CONCRETE OUTLINES		
REVISION	1	REVISION DESCRIPTION
DATE	03/13/2000	SUBMITTAL FOR APPROVAL

ESSENTIAL SERVICES PARKING GARAGE  
STOCKTON, CA

McCLONE CONSTRUCTION JOB #405

DISTRIBUTED ON 03/13/00 AS
<input checked="" type="checkbox"/> SUBMITTAL FOR APPROVAL
<input type="checkbox"/> PRELIMINARY INFORMATION
<input type="checkbox"/> REVISION NO. <span style="border: 1px solid black; padding: 0 5px;">1</span>
<input type="checkbox"/> OTHER
BY:
DATE:
DRAWING INDEX
ESSENTIAL SERVICES PARKING GARAGE STOCKTON, CA
McCLONE CONSTRUCTION COMPANY 4340 PRODUCT DRIVE • SINGLE SPRINGS, CA 95687 VOICE (530) 677-1027 • FAX (530) 677-3984
SCALE 1/4"=1'-0"
DOWN BY CSW
JOB 405
SHEET INDEX

DRAWING NO. P2.06A

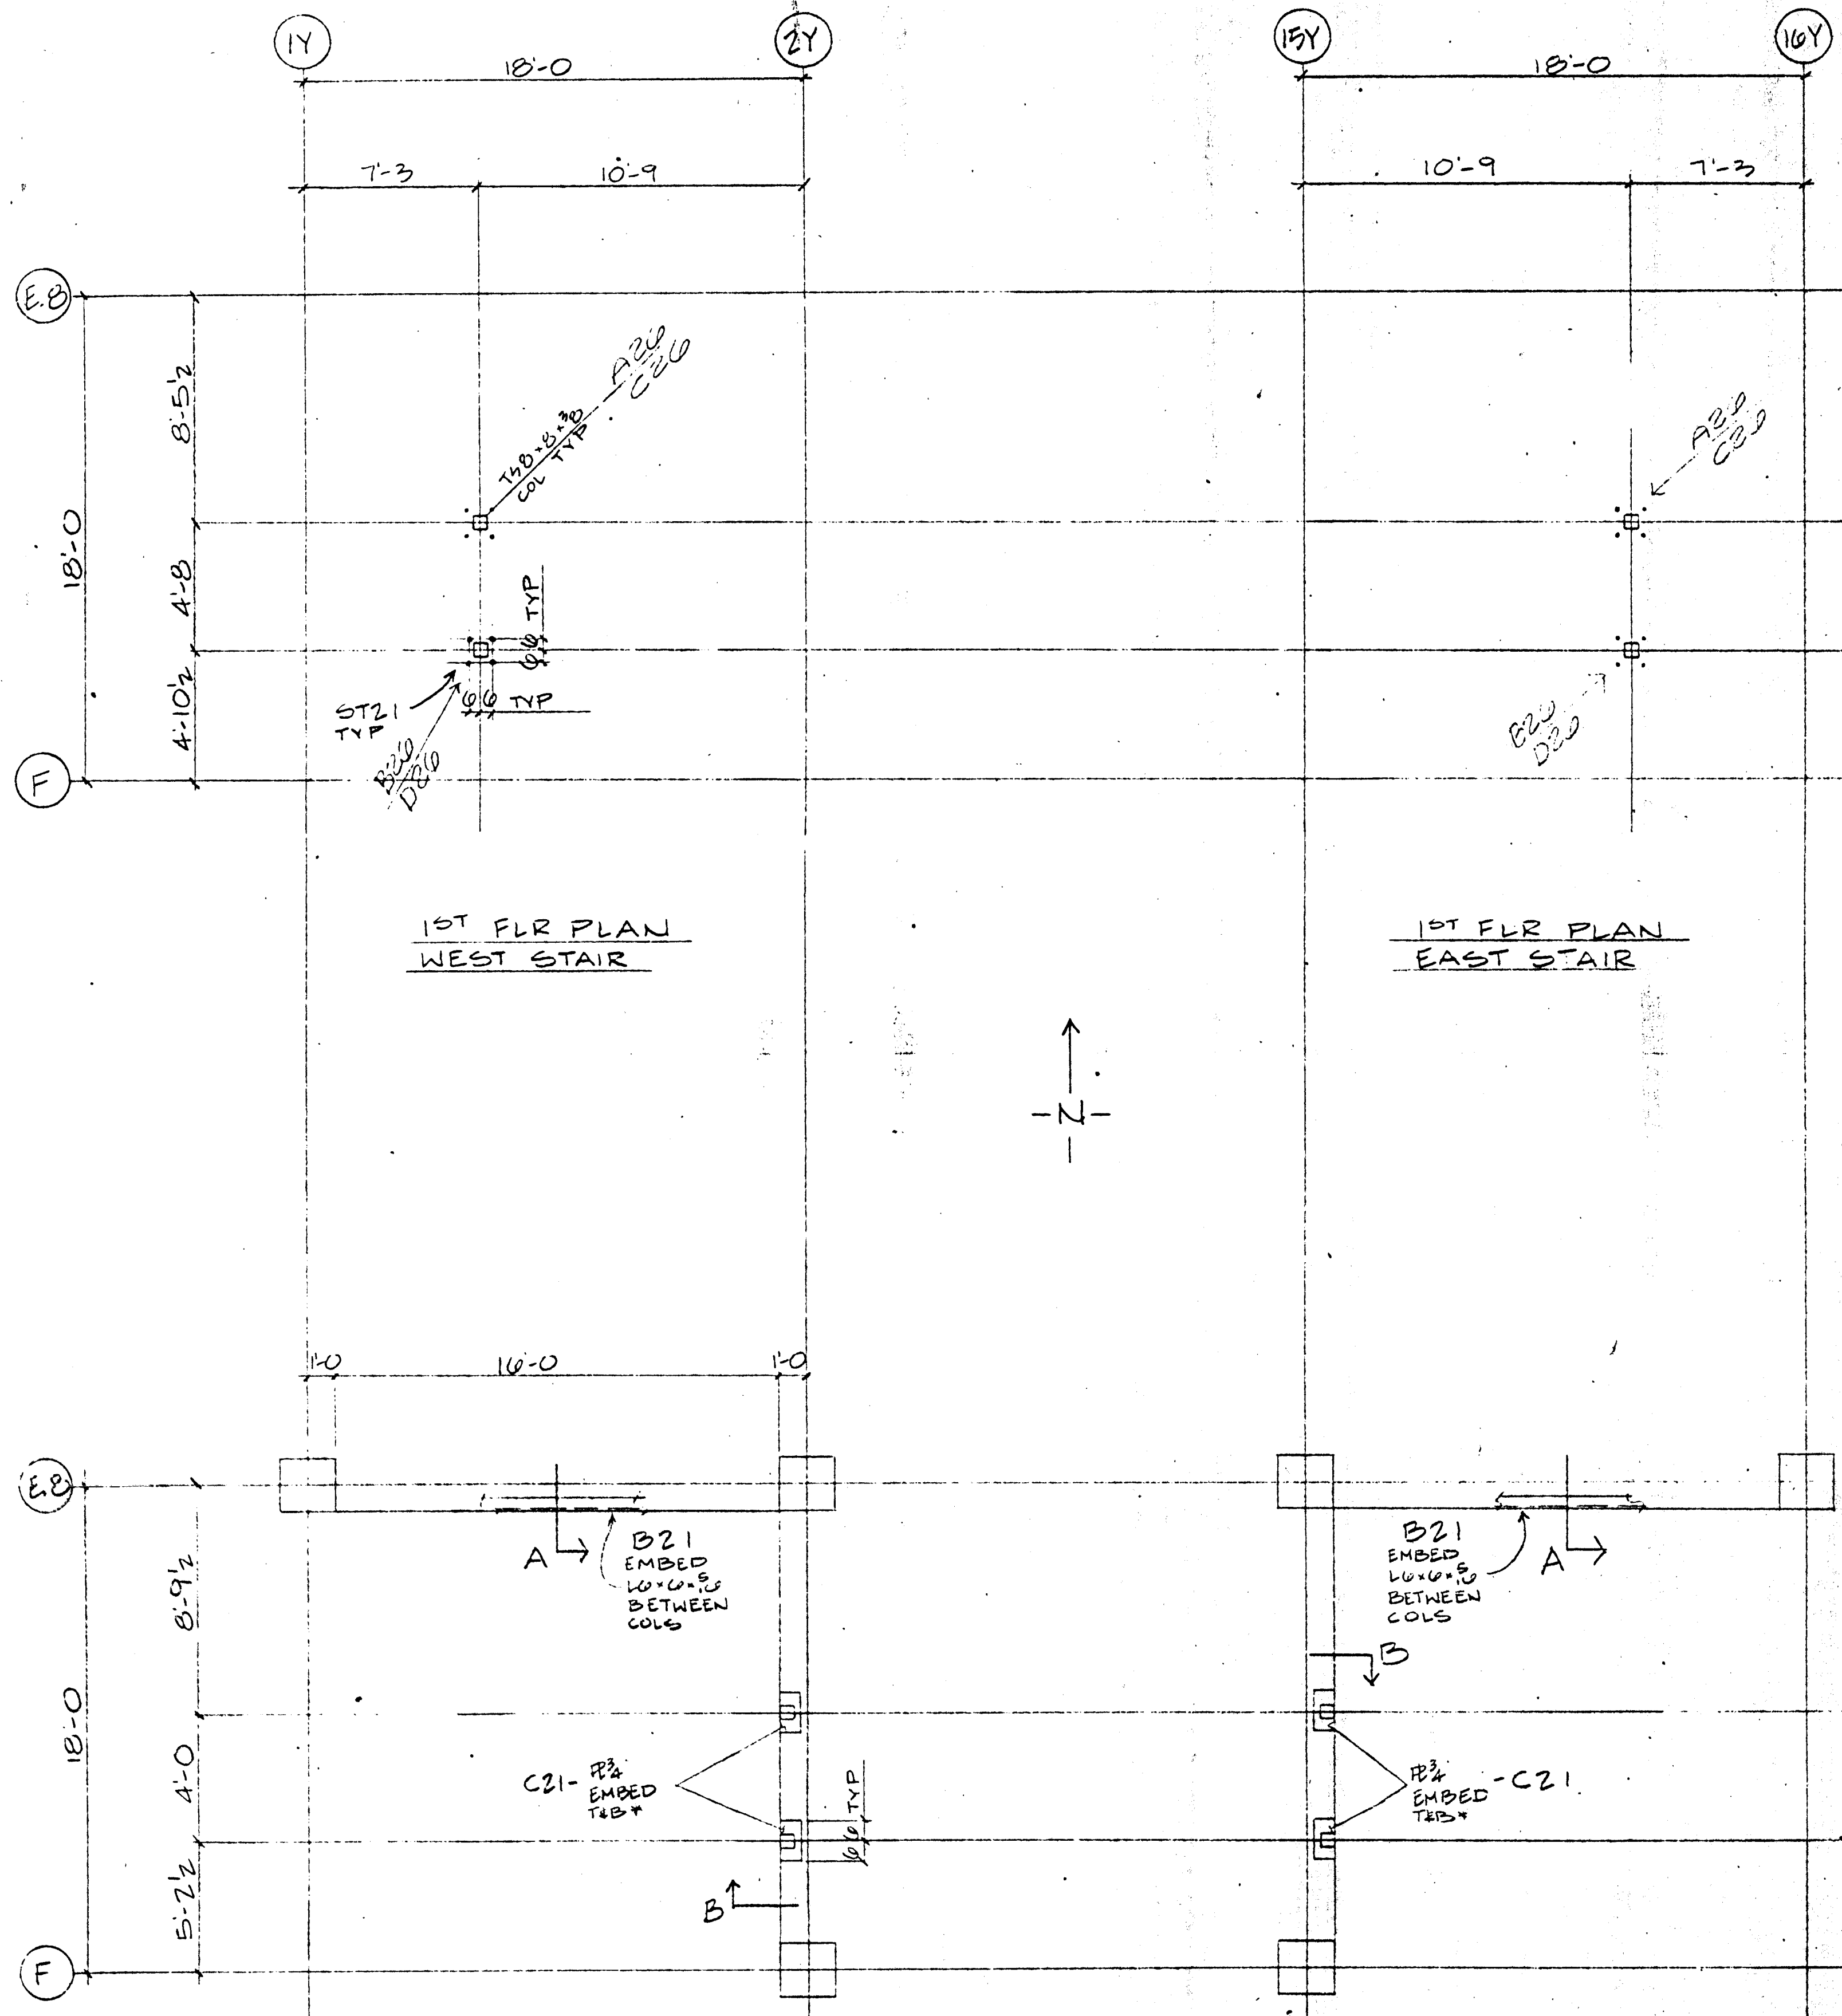
**REVISE & RESUBMIT STAIRS ARE REQUIRED TO BE STEEL STAIRS / CHECKER PLEASE**

SEE SHEET E8 FOR COMMENTS  
Architect verify stair dimensions & handrail typ

Submit plans & calcs. to Bldg. Dept. for approval. ✓ T. TURNER

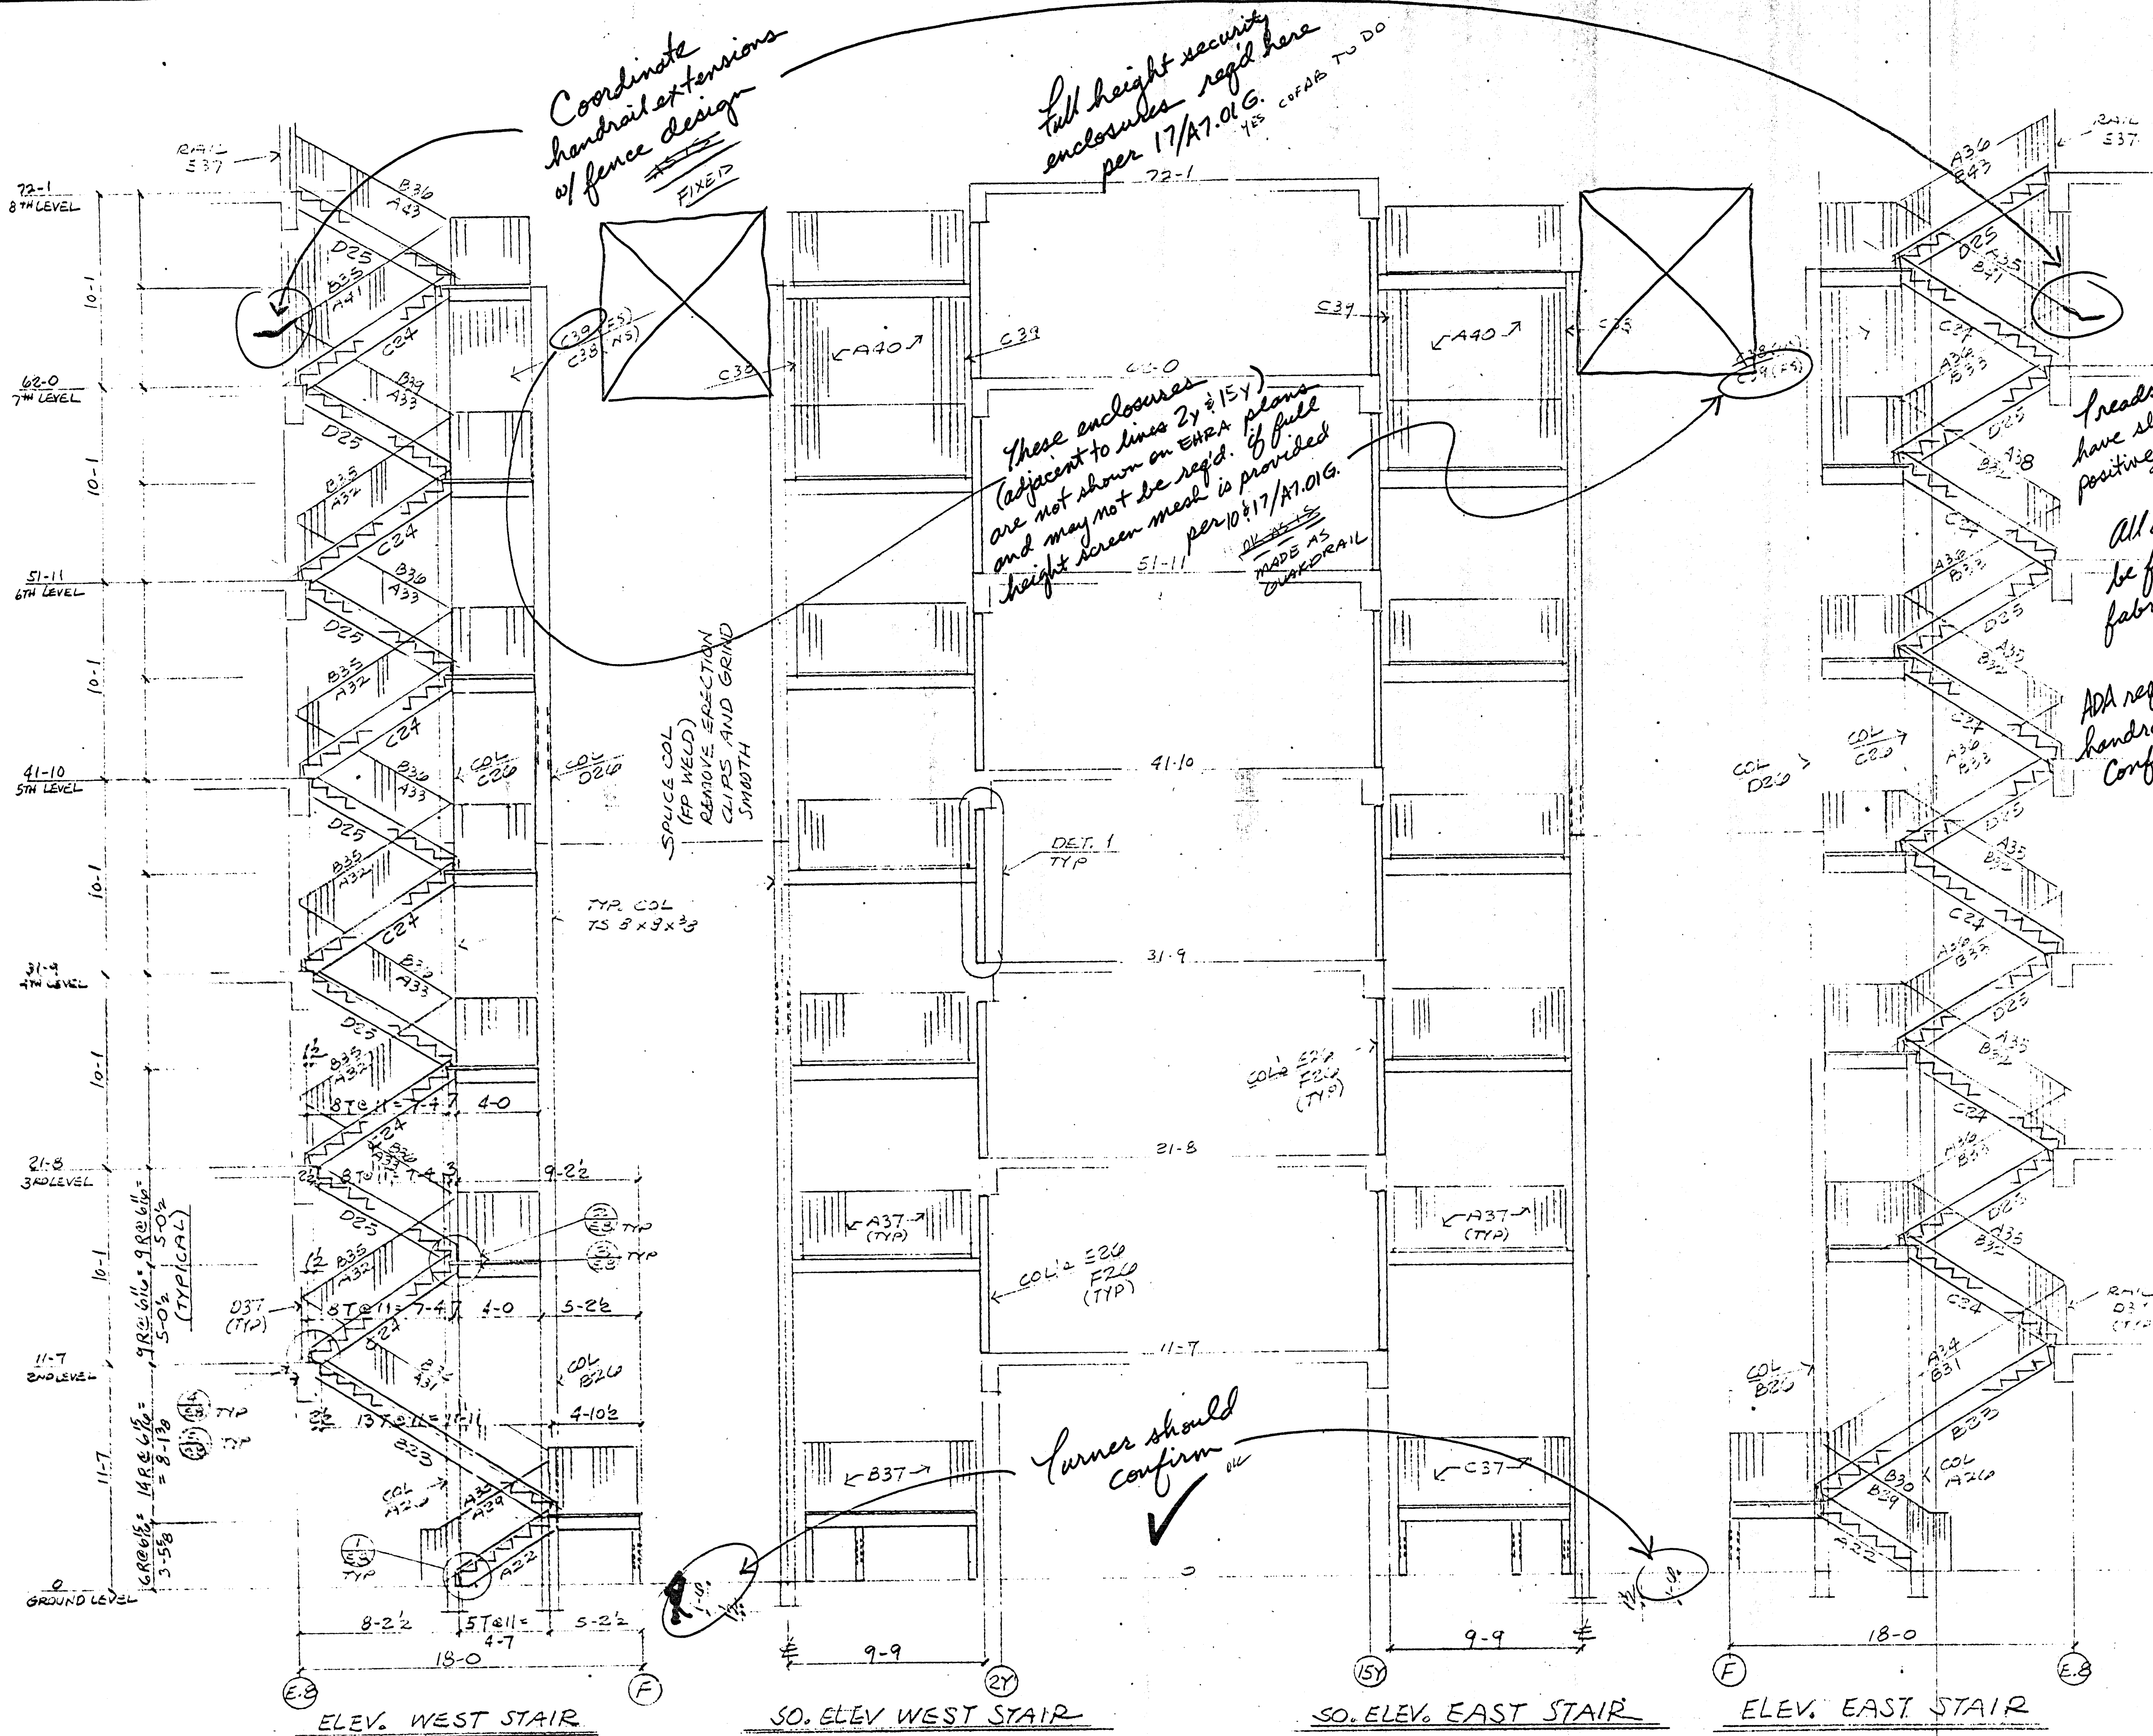
These enclosures  
adjacent to lines 2x & 15y  
are not shown on EXHA plans  
and may not be req'd. If full  
height screen mesh is provided  
per 10/17/A7.01.G.  
MADE AS  
HANDRAIL
